Bid#36-19
Spinney Road & Middle Street Sidewalks

Addendum #1
Issued: February 15, 2019

Addendum#1 adds two brick sidewalk sections to the Middle Street Site.

PROPOSED SIDEWALK PLAN
MIDDLE ST SIDEWALK PROJECT
PORTSMOUTH, NEW HAMPSHIRE
 for
CITY OF PORTSMOUTH
DEPARTMENT OF PUBLIC WORKS

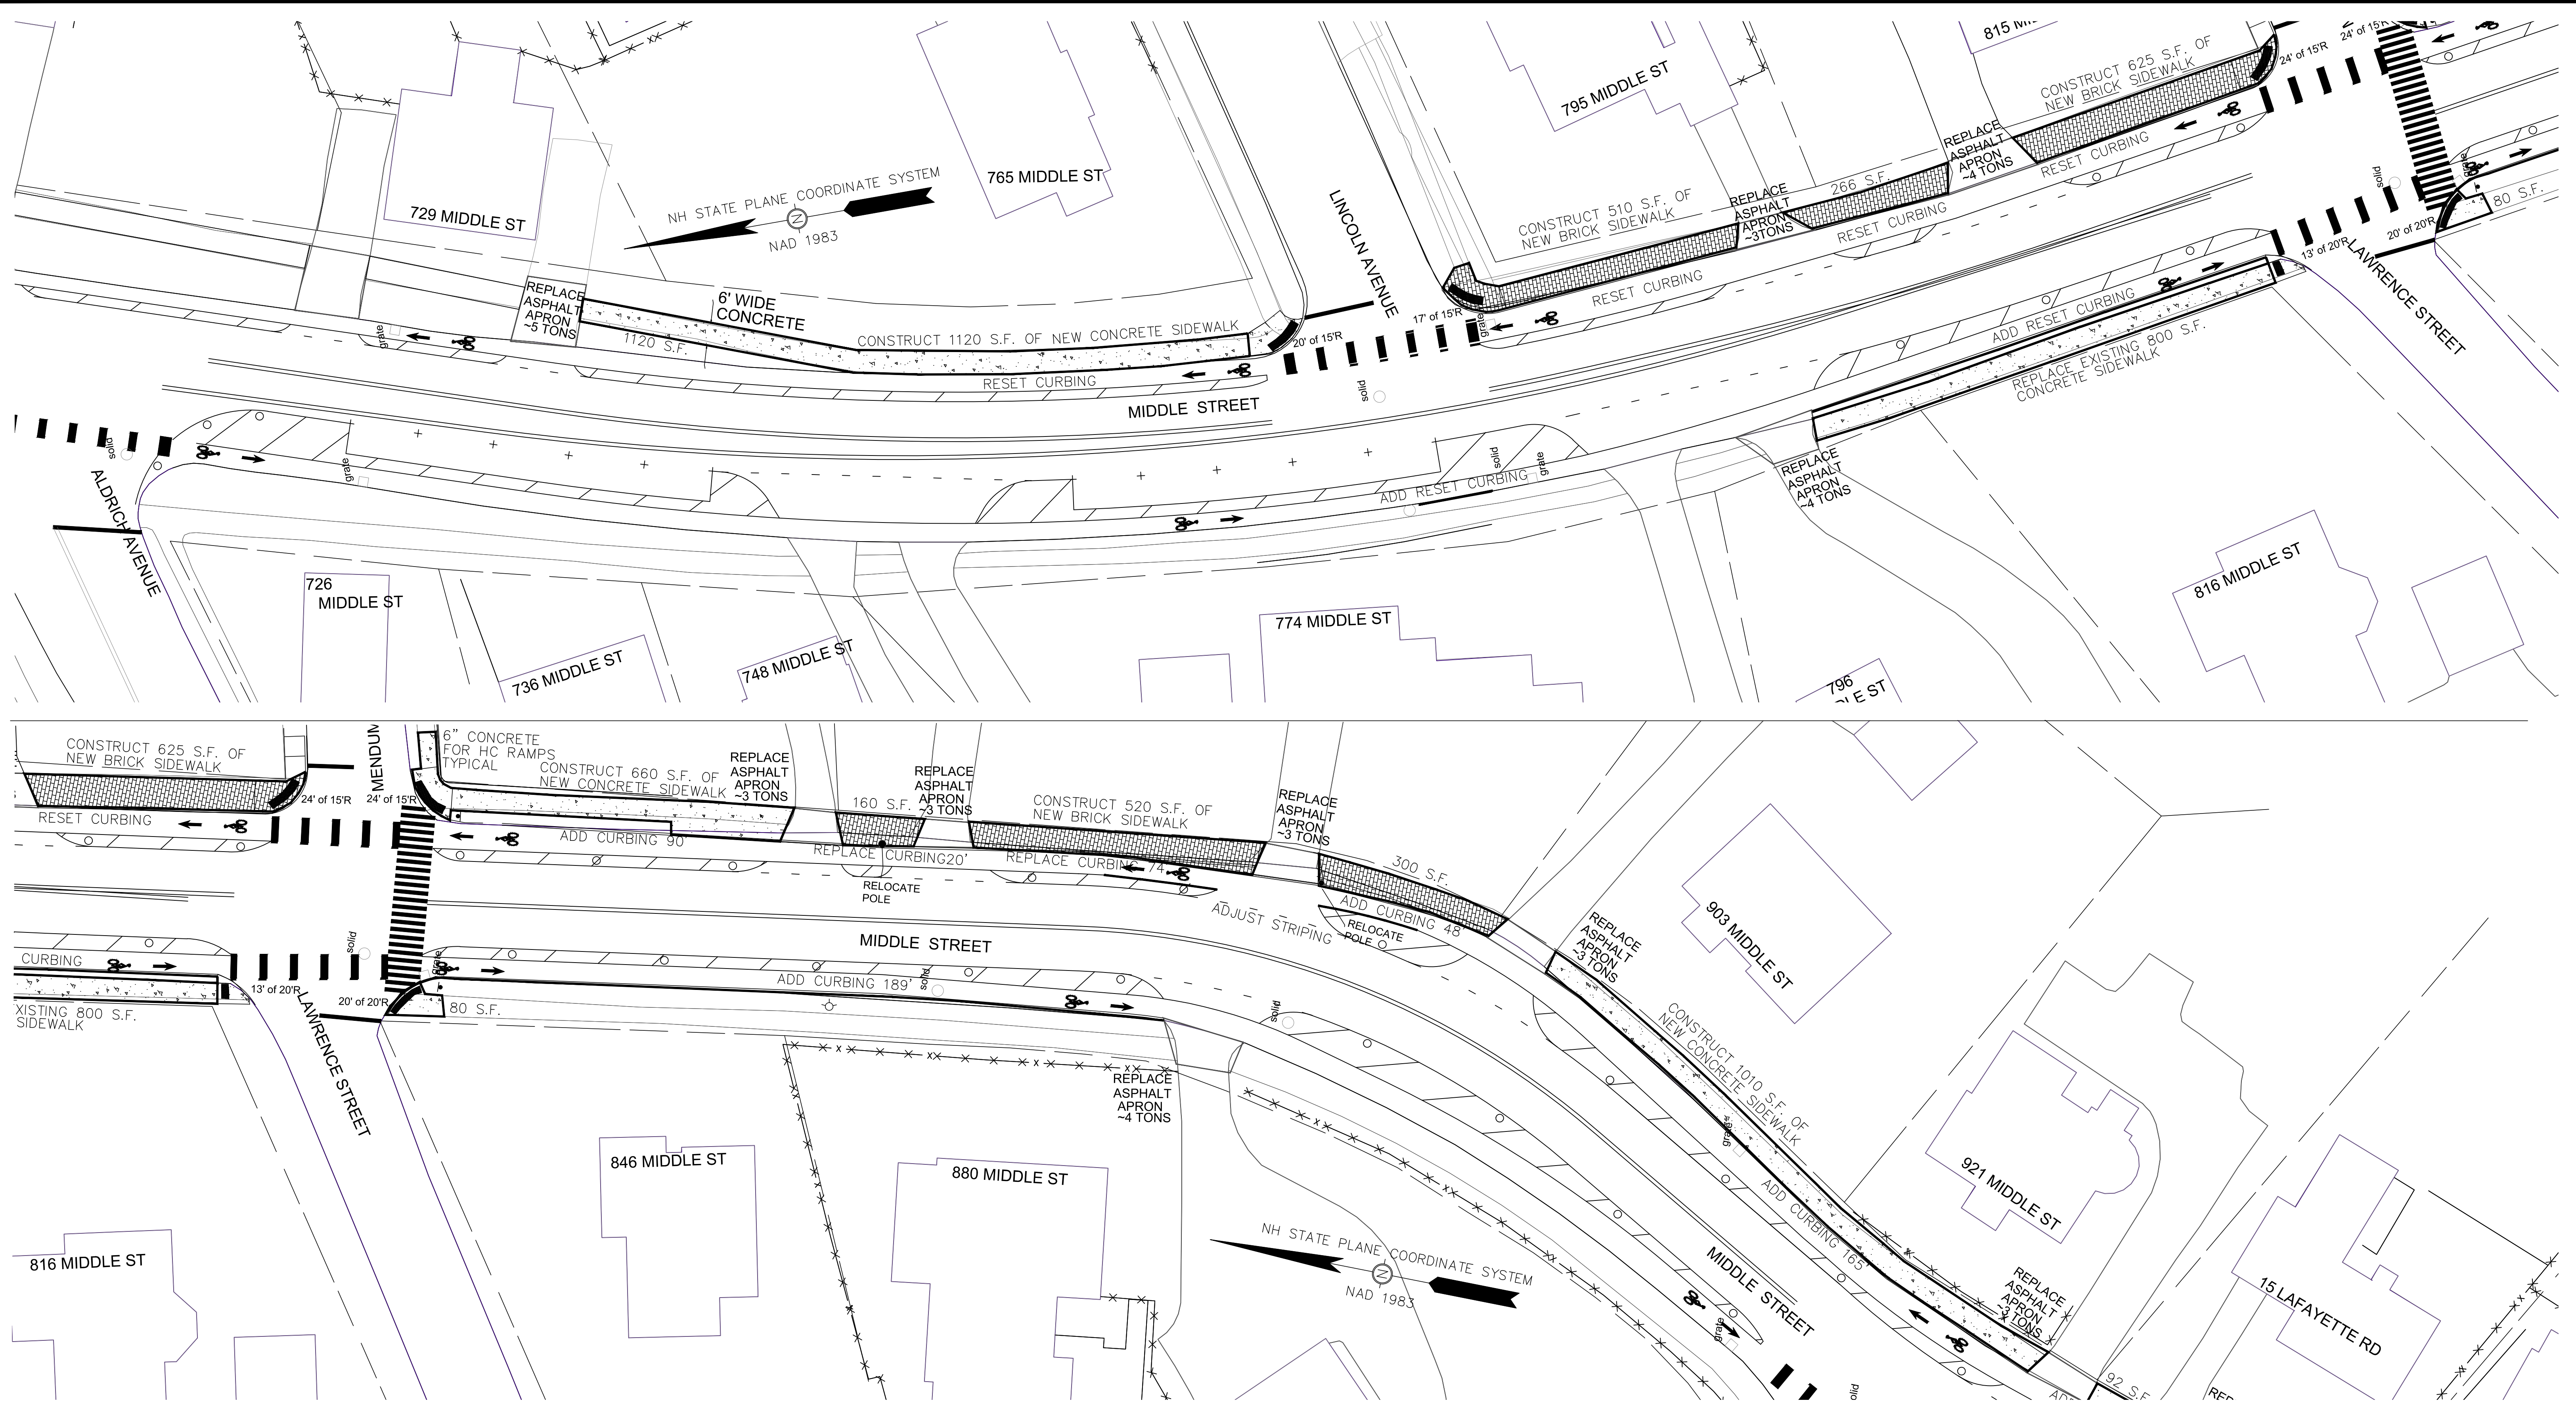
1. The bid proposal pages have been replaced in their entirety.
 - A Brick sidewalk bid item has been added.
 - Projected quantity of concrete sidewalks has been reduced.
 - Additional quantities have been added to Item 403.12 (hand method paving).
2. Added to specifications: SPECIAL PROVISION TO SECTION 608: Section 608.5 Brick Sidewalk.
3. Drawings revised in bid document: Middle Street sheet and detail sheet. See revised sheets 3 and 5 attached.

| REV. NO. | DATE | DESCRIPTION | D.W. |
|----------|-----------|-----------------------------|---------|
| 1 | 2/13/2019 | ADD BRICK SIDEWALK SECTIONS | APPRO'D |

PROPOSED SIDEWALK DETAILS
SPINNEY/MIDDLE SIDEWALK PROJECT
PORTSMOUTH, NEW HAMPSHIRE
 for
CITY OF PORTSMOUTH
DEPARTMENT OF PUBLIC WORKS

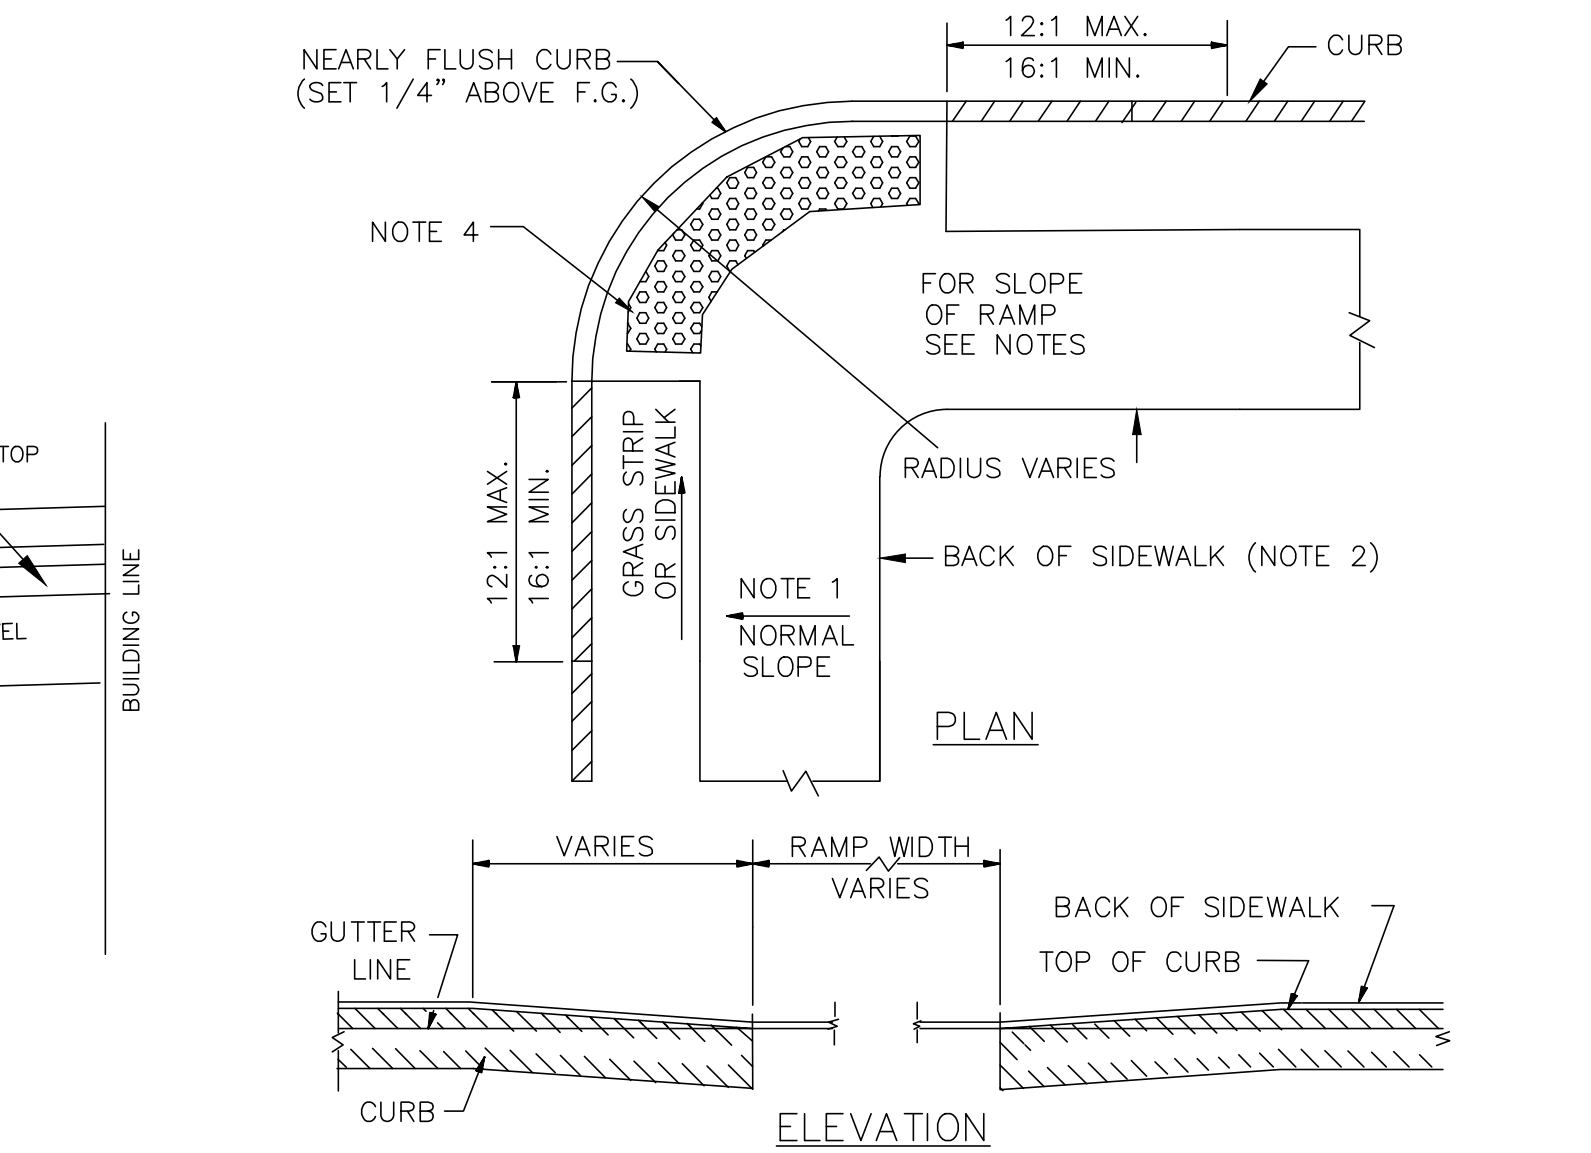
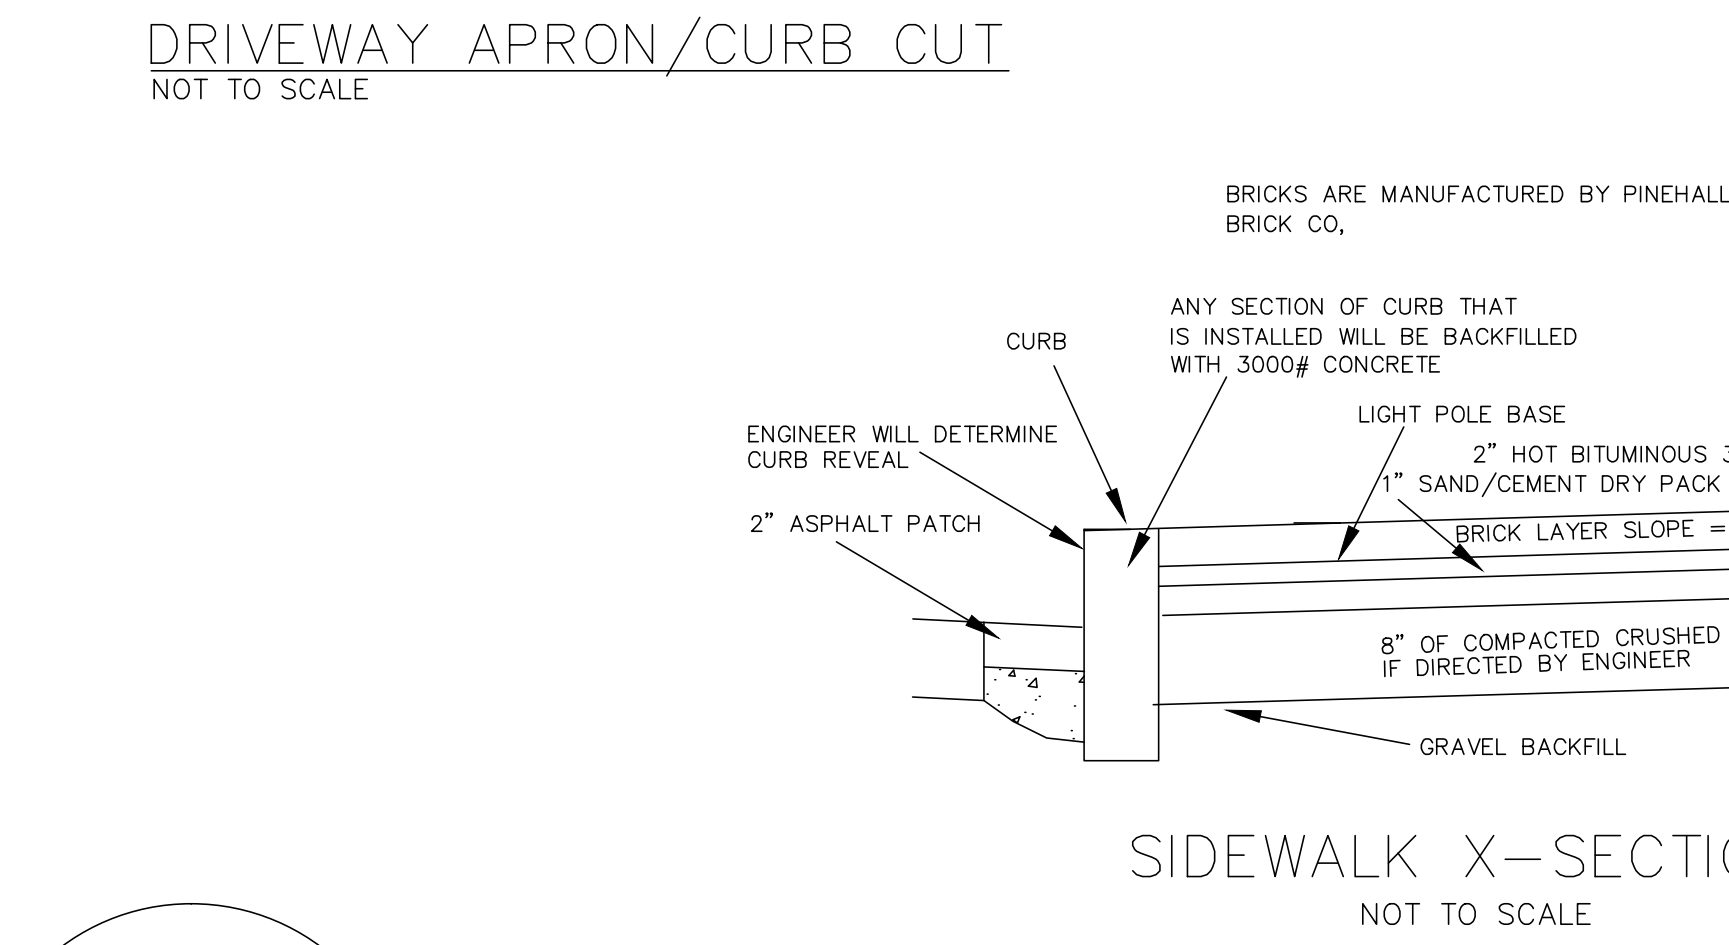
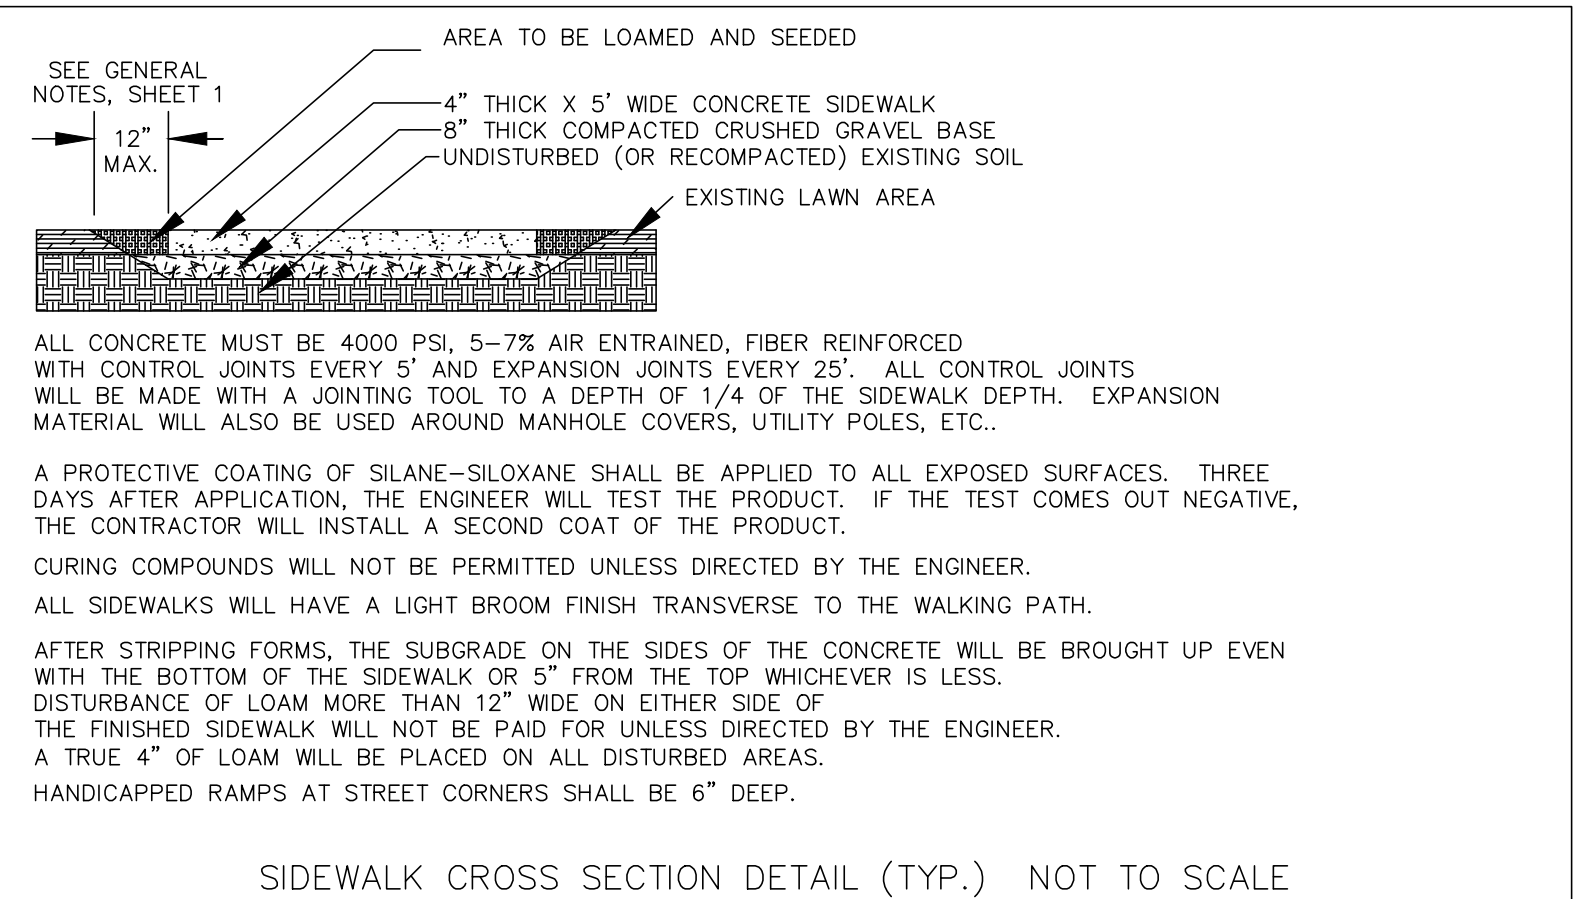
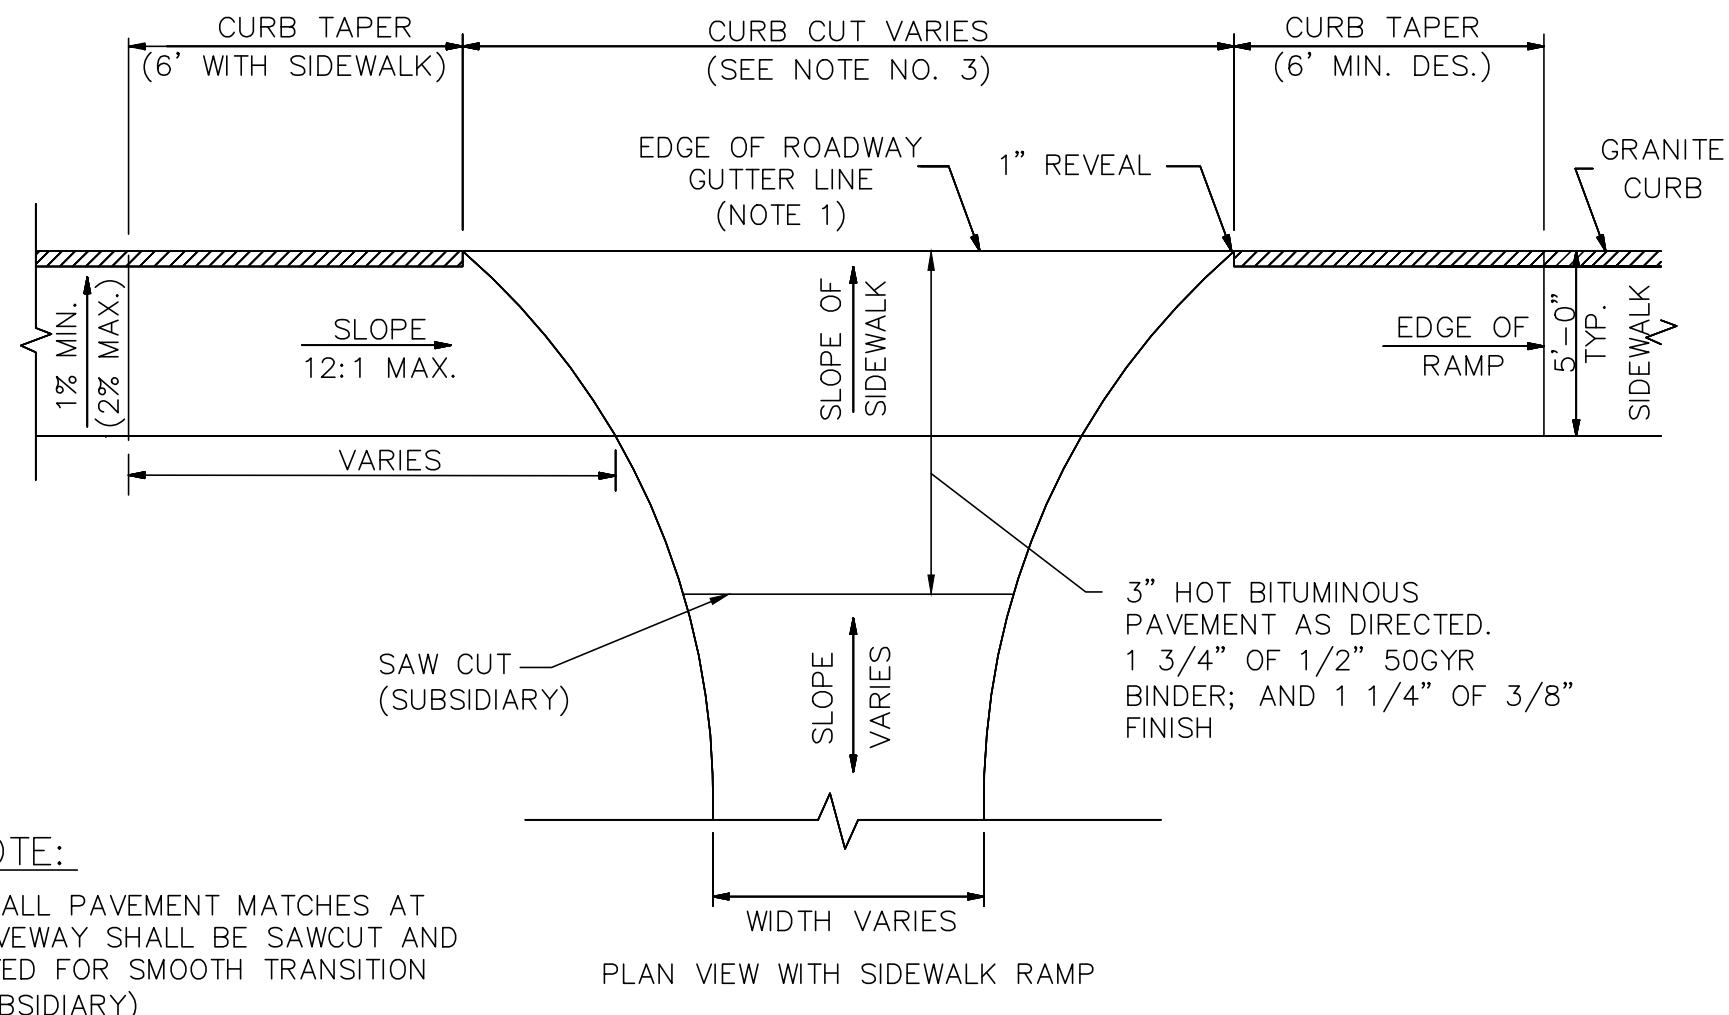
| REV. NO. | DATE | DESCRIPTION | D.J.D |
|----------|-----------|---------------------------|--------|
| 1 | 2/13/2019 | ADD BRICK SIDEWALK DETAIL | APPR'D |
